Docket: NRC-2018-0066

NUREG-2224, Dry Storage and Transportation of High Burnup Spent Nuclear Fuel, Draft Report for Comment.

RE: NUREG-2224 High Burnup Storage and Transport Draft Comments from Donna Gilmore,
 Docket NRC-2018-0066

Figure 20 Cladding Outer Surface Oxide Layer Thickness versus Rod Average Burnup (Gigawatt days/ton of uranium). NWTRB 2010

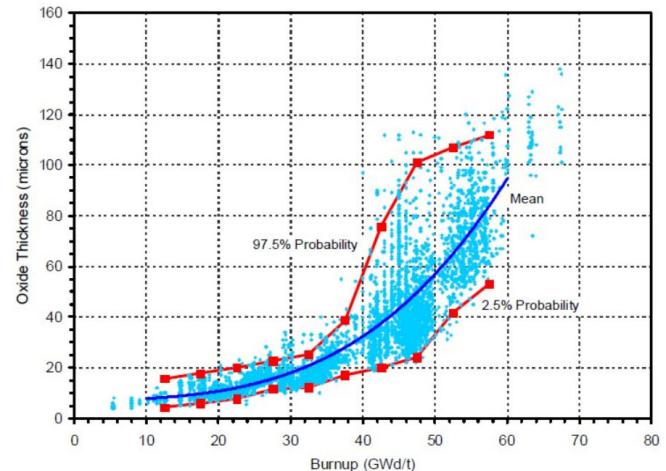
Plotting more than 4,400 measurements from commercial fuel-rods taken from reactors around the world, Figure 20 shows the maximum outer-surface oxide-layer thickness data in low-Sn Zircaloy-4 cladding plotted as a function of burnup. Taking these oxide thickness measurements, the maximum wall thickness average (MWTA) hydrogen content can be calculated using a hydrogen evolution model. Figure 21 plots the wall-average hydrogen content in low-Sn Zircaloy-4 cladding as a function of burnup from both measured and model-calculated data. For a discharge burnup in the range of 60-65 GWd/MTU, the maximum oxide thickness is 100 µm and the average hydrogen concentration is 800 ppm, which corresponds to a metal loss of 70 µm using conservative assumptions.

The NRC continues to ignore this operating data. I have asked in numerous NRC technical meetings over the years why the NRC ignores this data, including at the one public meeting held on NUREG-2224 (September 6, 2018). Normally the NRC will respond with some type of answer to my questions. When I ask about this operating data, they don't even do that. They change the subject. I would like a response as to why the NRC ignores this data.
